CERTIFICATE OF APPROPRIATENESS PLACARD

211 E SOUTH STREET

006-16-MW

Raleigh Historic Development Commission – Certificate of Appropriateness (COA) Application

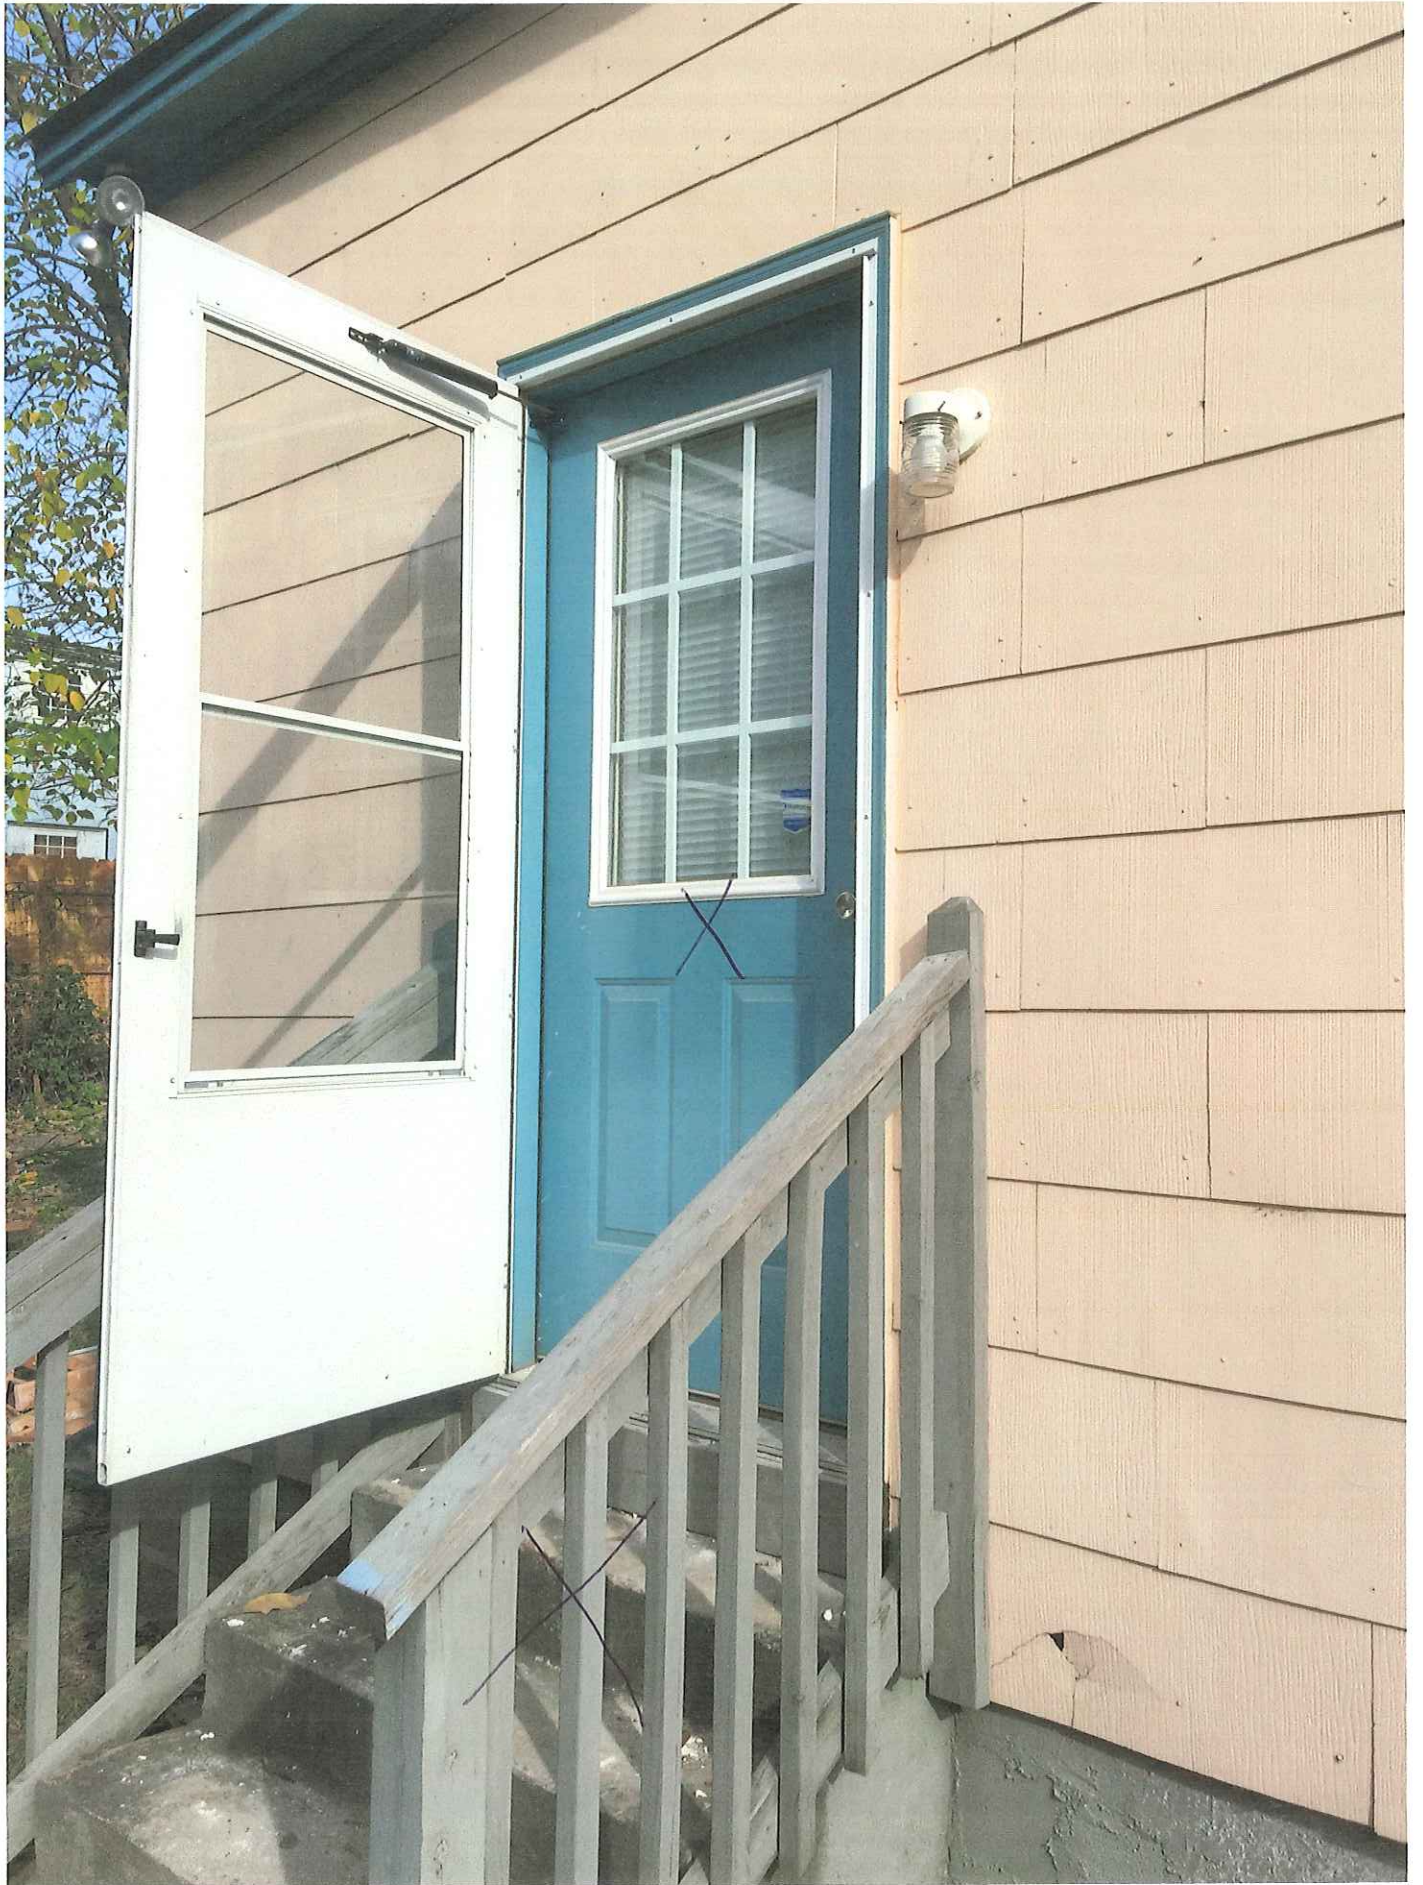
- Please identify (in the photo) the small section of old concrete siding to be replaced. The replacement siding should have as similar texture to the existing as possible. You mention hardie-plank siding. James Hardie does have a product that may work, but the texture is different from what I can tell: <http://www.jameshardie.com/Products/HardieShingle-Siding> A better option may be the historic looking fiber cement siding available from GAF. Product page: <http://www.gaf-weatherside.com/index.html> Please include a close-up photo of the existing siding and specs on the specific product selected.

- Please confirm the height of the new stair railing. If required to be taller than the existing porch railing (likely), then a new simple black metal railing is more appropriate to the house.

Replace current, rusted Mailbox with new. Material include "Special Lite SHH-1006 Horizon Horizontal Mailbox". See Picture #8 and #9.

Picture #1

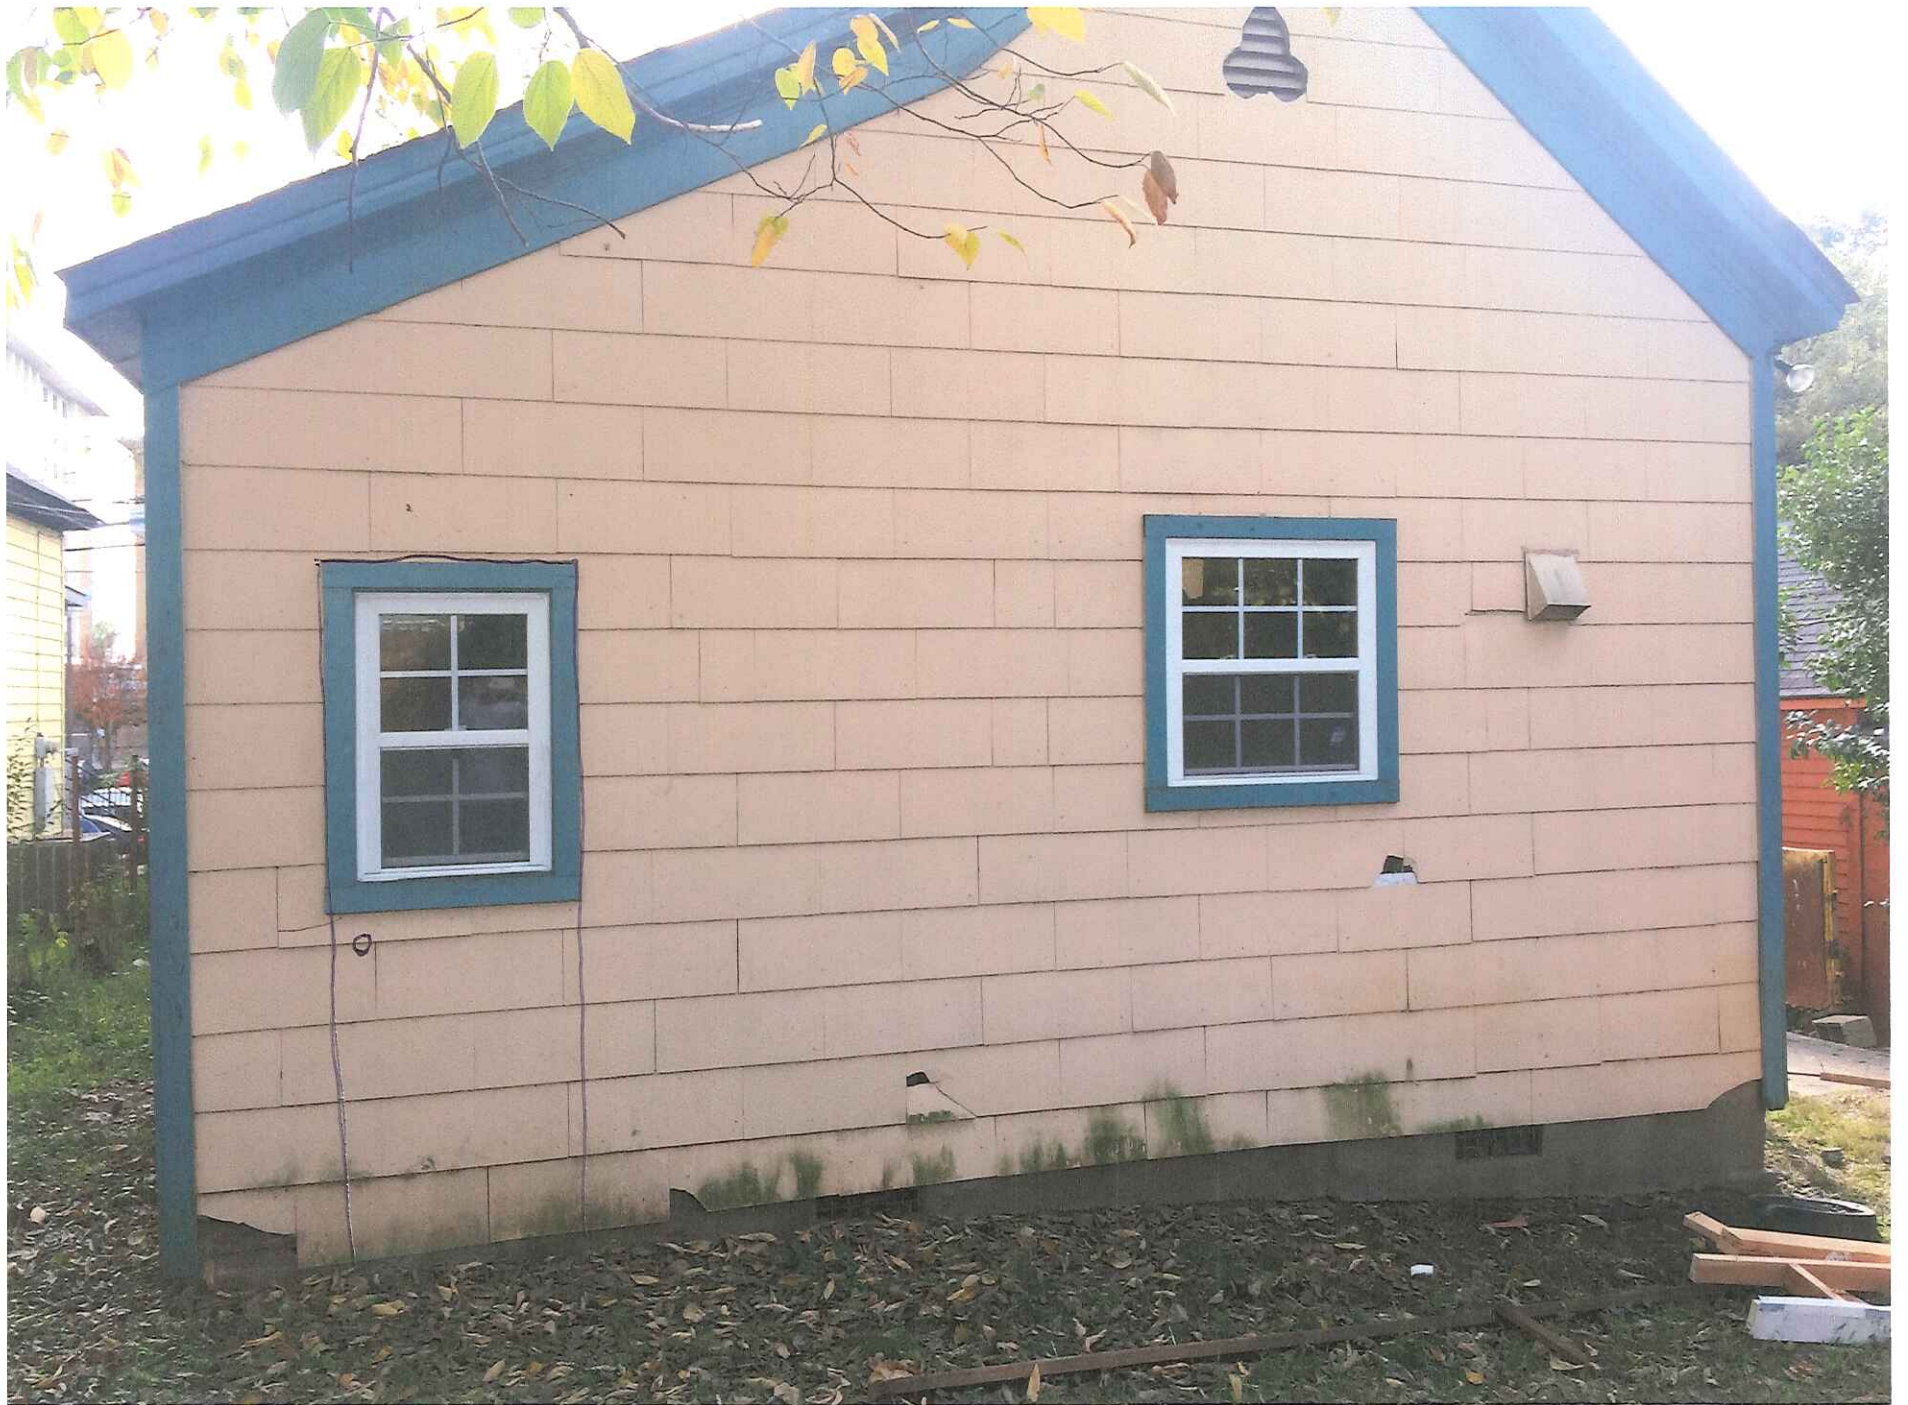
·Please identify (in the photo) the small section of old concrete siding to be replaced.

Attached is a picture showing the proposed area of siding to be replaced. It would be the top, triangle portion highlighted below.

I have included a picture outlining the area. The old siding taken down from the front will be used on the left, backside of the house where the present back door exists. The old siding will be woven in so as to have no vertical seams (aka: it will look like there was never a door there).

Backdoor Exterior Light

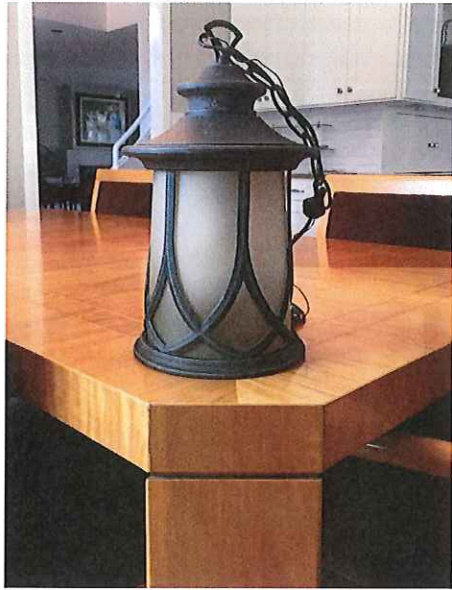
Hinkley Freeport 9 ¼" High Bronze Outdoor Wall Light
Style # N9353
